KEY INFORMATION**Ward** The Ferry**Proposal**

Erect one dwelling house with detached garage and new boundary wall/fence and demolish existing garden shed

Land To South Of 3
Balmyle Road
Broughty Ferry

Proposed New House in Balmyle Road

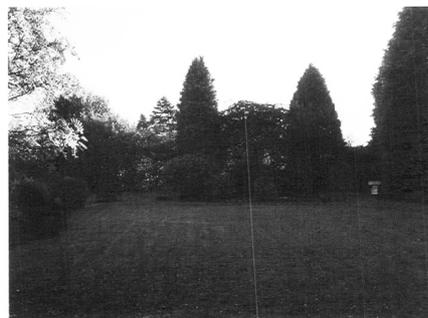
A new light green *Lawson's cypress* will be planted in the gap behind the *cherry laurel* on the west boundary.

The existing light green *Lawson's cypress* on the south boundary is to be retained.
The *cherry laurel* and *cotoneaster* to the west of the above cypress are to be felled to accommodate a detached garage.
